# 802.1AB/D11 Sponsor Confirmation Ballot Comment Summary

Paul Congdon

10/06/2004

# Proposed RX State Machine

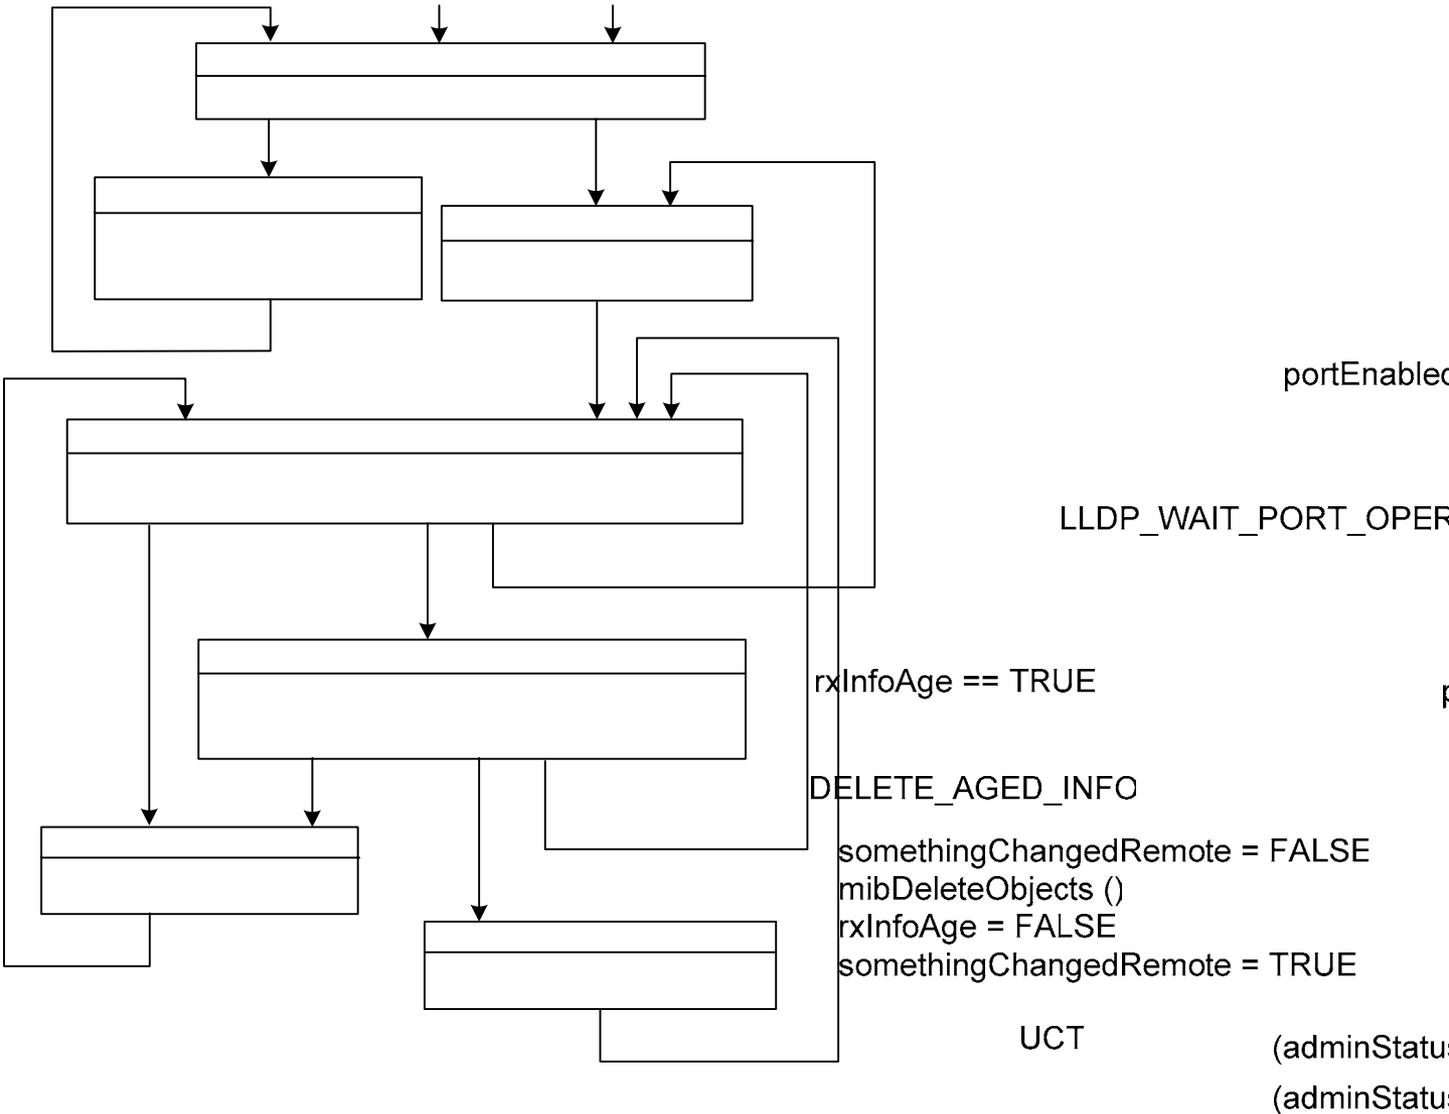
- Compiled from bugs or confusion found by early implementers
- Comment summary
  1. OID field encoding not specified
  2. statsFrameDiscardedTotal not counting discards due to lack of space (i.e. tooManyNeighbors)
  3. Rx state machine does not age remote entries when port is down
  4. Rx state machine does not handle bad LLDPDUs
  5. Confusion around Rx state machine instances
  6. Non-SNMP management conformance statement
  7. Error in 802.3 TLV diagram with remote fault indication
  8. Error in 802.3 TLV diagram for Power over DTE
